# LAND AT MODEL FARM, PORT ROAD, RHOOSE, VALE OF GLAMORGAN

Rebuttal Note to Viridian Landscape's appraisal of RPS/TT  
LVIA

Land At Model Farm,  
Rebuttal to Viridian  
Landscape's appraisal of  
RPS/TT LVA  
V3.0  
March 2026

Status Planning  
 Drawn By SH  
 PM/Checked By KH  
 Project Number JSL3282  
 Scale @ A3 1:40,000  
 Date Created JAN 2026  
 Figure Number 5  
 Rev B

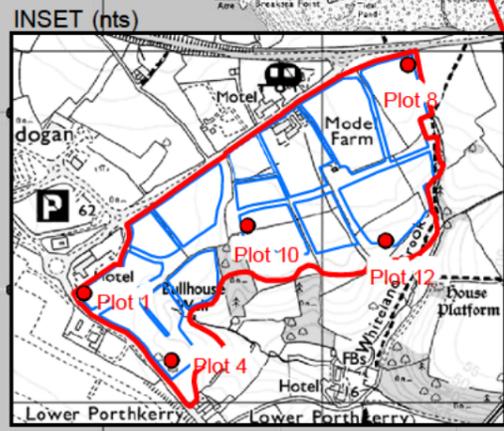
- 1.38 **Viridian:** Drawings missing information referenced in text; inaccuracies in identification of the public footpath FP PROW P4/17/1 adjacent to the site along Whitelands Brook; ZTV building-height criteria unclear and viewpoint locations hard to distinguish on plans.
- 1.39 **RPS Response:** RPS rebut Viridian’s assertion of inaccuracies in the location of PRoW footpath PROW P4/17/1 and that the proposed building heights are missing for the purposes of modelling the Zone of Theoretical Visibility (ZTV). Additional figures have been produced and attached to this Rebuttal Note in relation to the above.

Notes:  
 The ZTV was computer generated using Key Terraforma (KTF) software. It has been generated using the top height of 5 buildings within the proposed development area and takes into account the visual screening offered by buildings (at 9m) and significant blocks of existing vegetation (at 12m) within the Study Area.

B	ZTV origin heights revised	SH	HD	07/19
A	Inset added with ZTV origin point information	SH	KH	07/19
Rev	Description	By	CB	Date
